FORMER ARCO SERVICE STATION #6002  
 6235 SEMINARY AVENUE  
 OAKLAND, CALIFORNIA  
**SOIL AND GROUNDWATER INVESTIGATION  
 WORK PLAN**

**SITE MAP WITH PROPOSED  
 BORING LOCATION**

Subject: Site Characterization Work Plan for Fuel Leak Case No. RO0000163 and GeoTracker  
Global ID T0600100105, ARCO #6002, 6235 Seminary Avenue, Oakland, CA 94605

FIGURE  
**2**

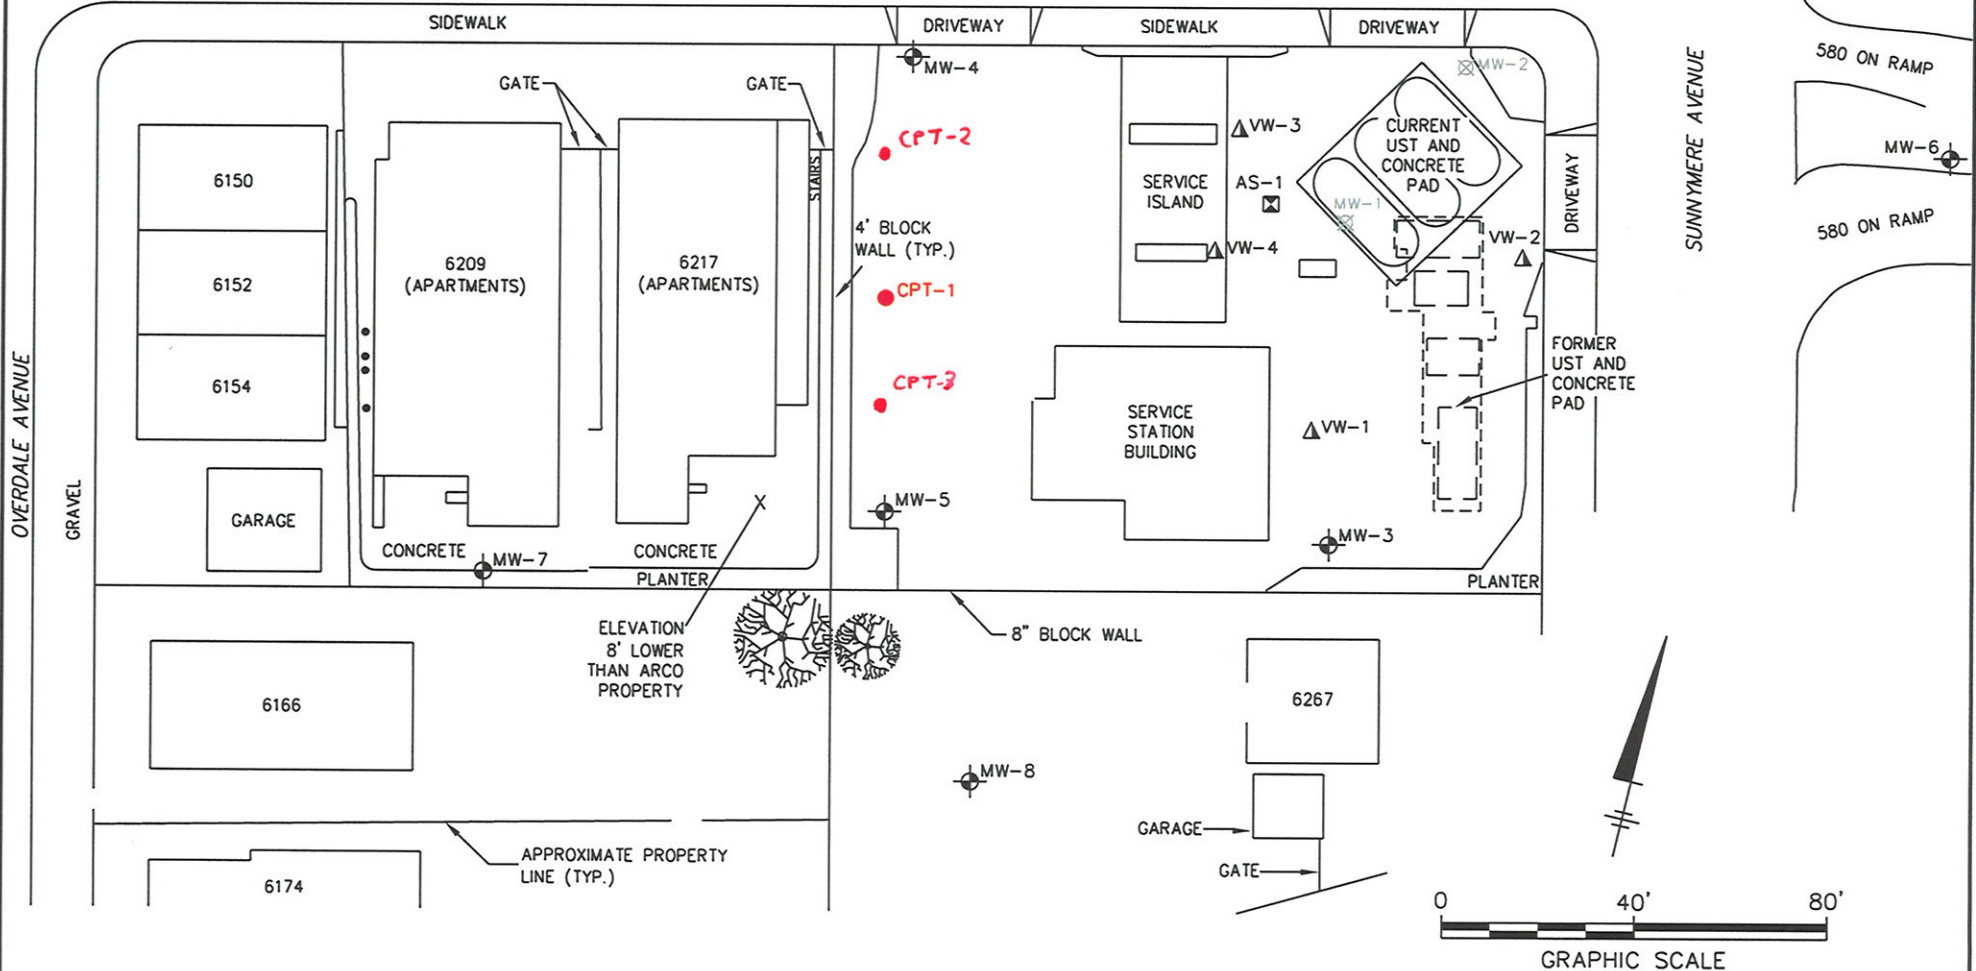
1. **Soil and Groundwater Characterization & Cone Penetrometer Testing** – As identified in our May 22, 2009 correspondence, it appears that there are no monitoring points down-gradient of the dispenser islands. Monitoring well MW-4, located on the northwest corner of the site, has not detected hydrocarbon contaminant concentrations above the laboratory detection limit, while the highest concentrations of hydrocarbons have been detected in monitoring well MW-5, located on the southwest corner of the property, which is over 90 feet south of monitoring well MW-4. Therefore, there is an expanse of over 90 feet between monitoring wells MW-4 and MW-5, down-gradient of the dispenser islands that remains uncharacterized. In response to ACEH concerns, Arcadis proposes to install one CPT boring to a depth of 25 feet bgs between monitoring wells MW-4 and MW-5. ACEH is concerned

that there is a multi-family residential building down-gradient of the subject site and the scope of work proposed may not adequately characterize the site. ACEH requests that at least two additional CPT borings are installed to form a transect of borings between monitoring wells MW-4 and MW-5 so that the extent of contamination down-gradient of the source area(s) can be adequately assessed. Please submit a revised figure by June 3, 2010 and submit a completed report by September 1, 2010, as requested below.

In response to the attached directive here is a revised figure showing the locations of two additional CPTs at Former BP Site 6002 (ACEH R0163). We will schedule this work immediately.
